**AGENDA
PLANNING COMMISSION
CITY OF ROELAND PARK, KANSAS
ROELAND PARK
4600 W 51ST STREET
SEPTEMBER 17, 2019 6:00 PM**

1. Rezoning and Preliminary/Final Development Plan Approval at the northeast corner of Johnson and Roe

Date: 9/17/2019
Submitted By: John Jacobson, Building Official
Committee/Department:
Title: Rezoning and Preliminary/Final Development Plan Approval at the northeast corner of Johnson and Roe
Item Type: Other

Figure 2- Proposed Development

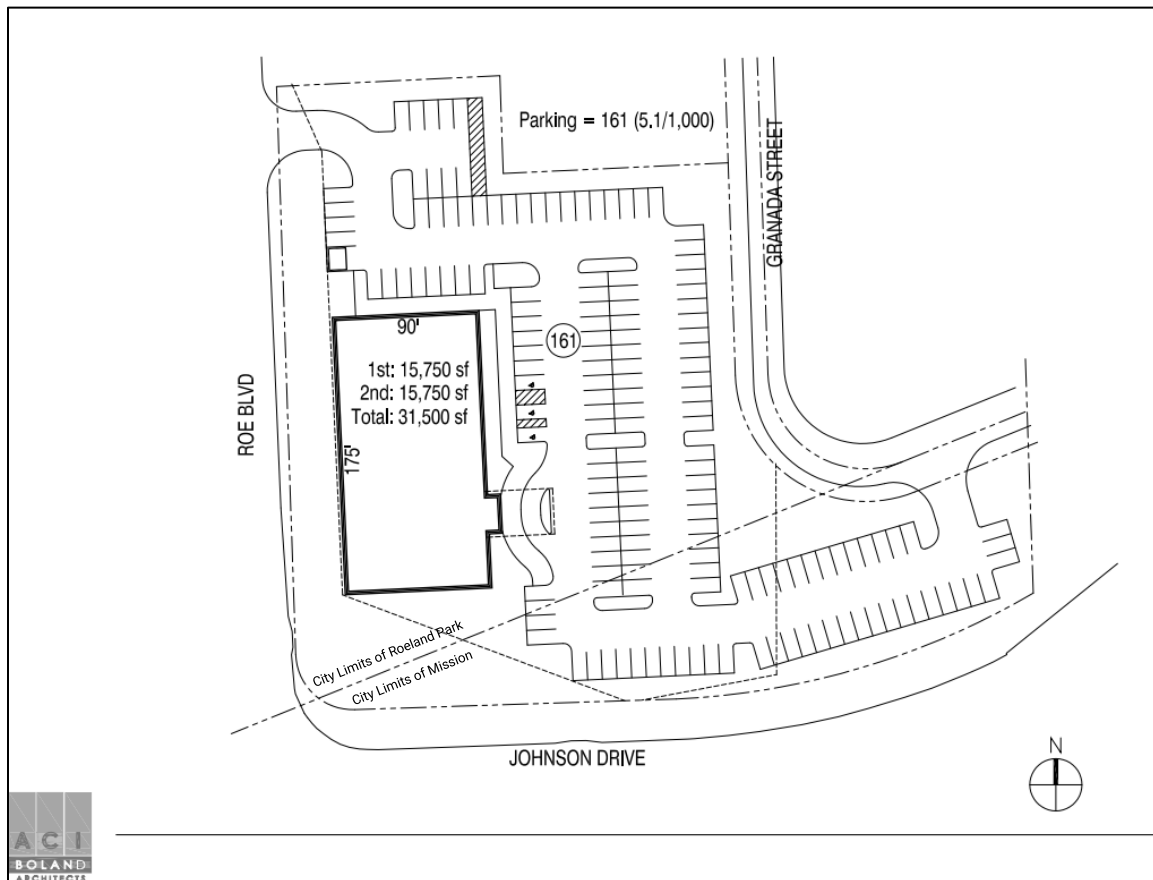
1. Please label the City Limit line across the development site on Figure 2 (Proposed Development), as stated in the paragraph at the top of Page 5.

Added city limit label to Figure 2

Figure B-2

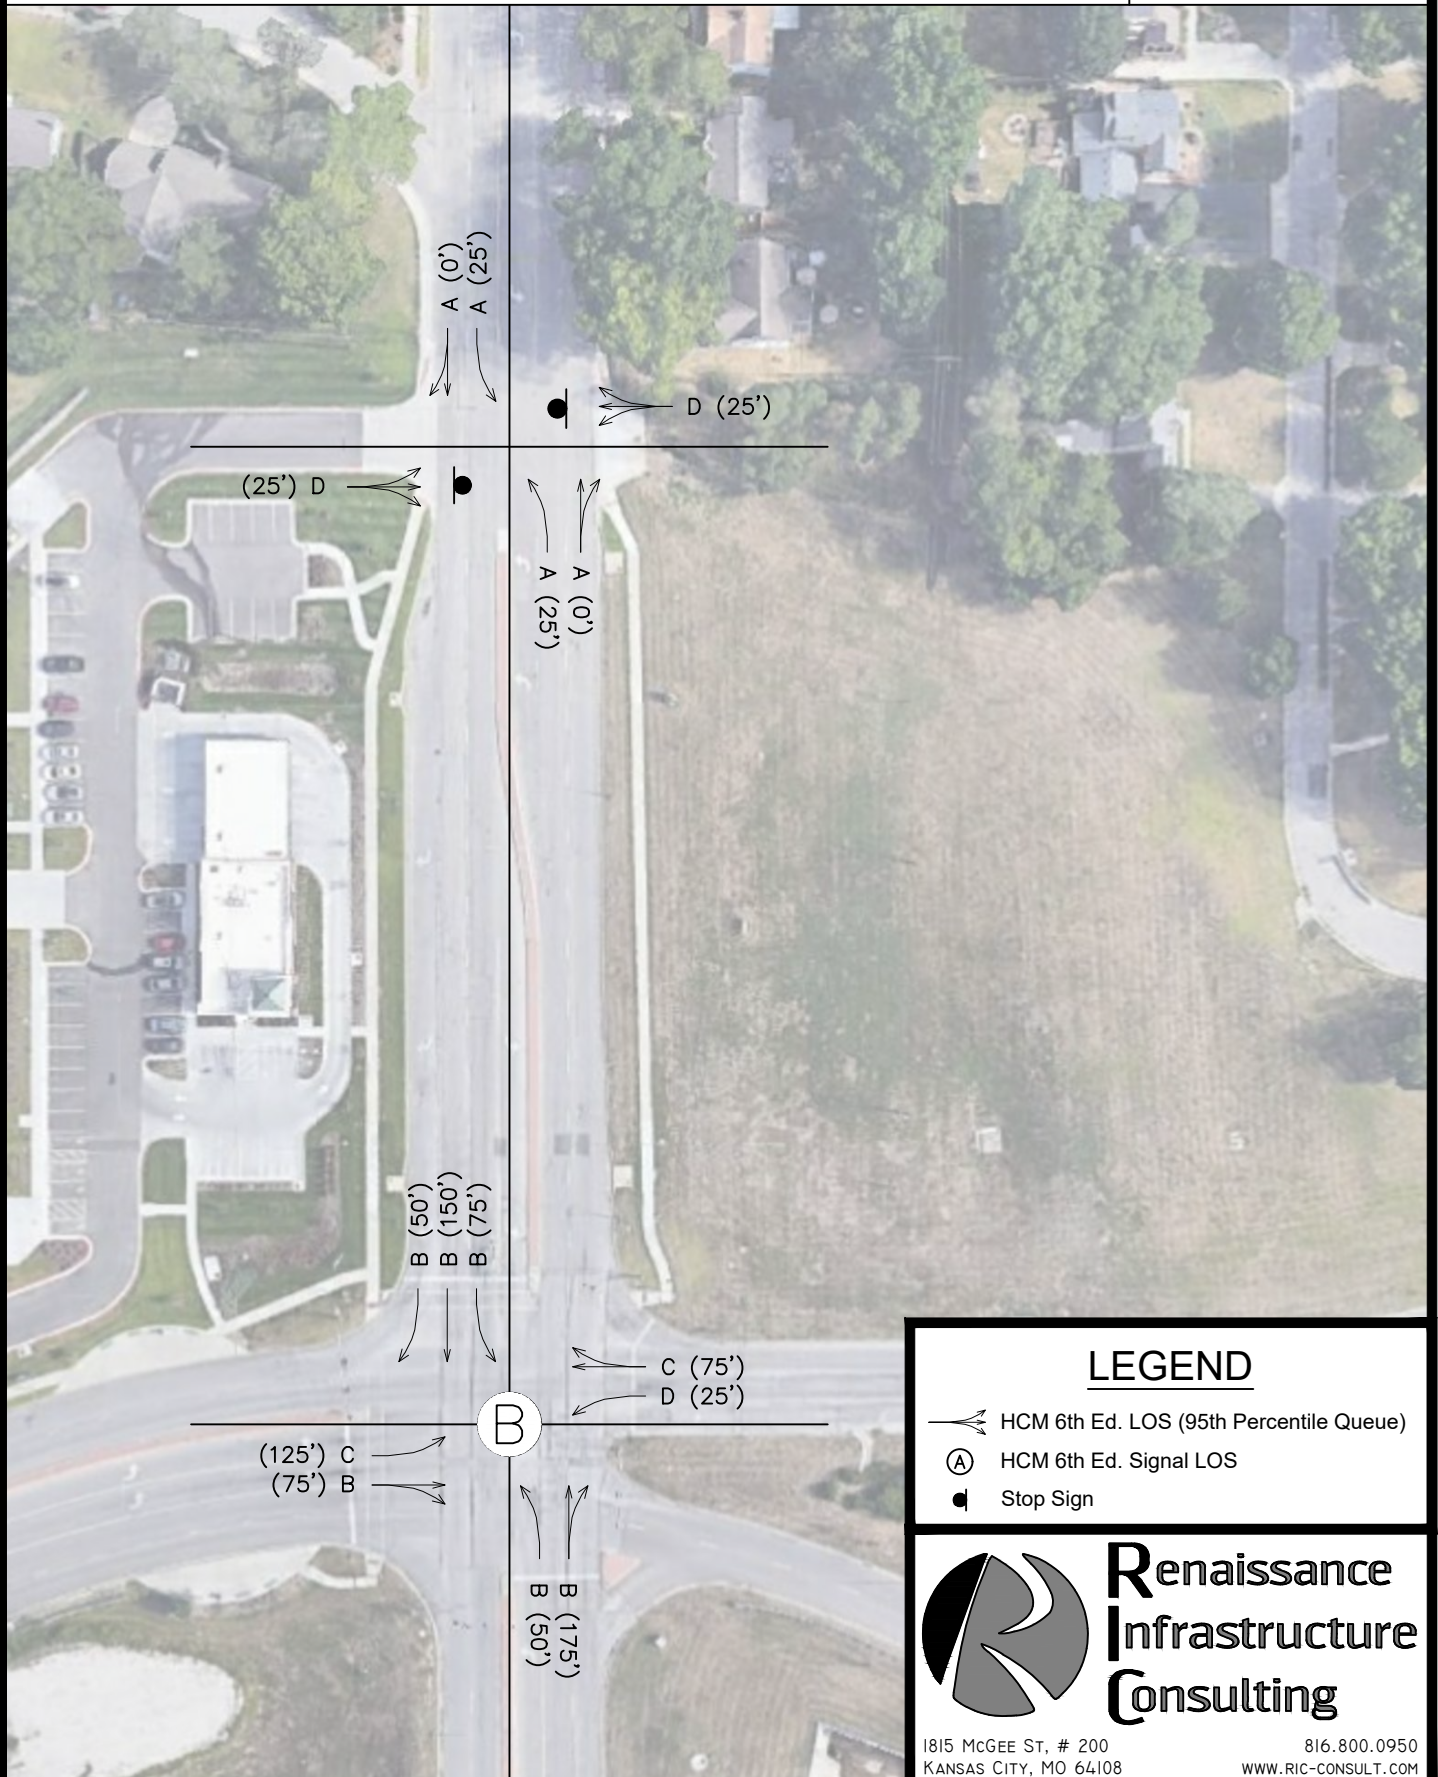
- On Figure B-2 for the “Existing + Development Levels of Service” during the AM Peak Hour, the eastbound and westbound movements at the private drives onto Roe Avenue should both be LOS “D” to match the accompanying analysis and the intersection summary provided in Table 4.

Updated Figure B-2’s LOS for E/W at the private drives
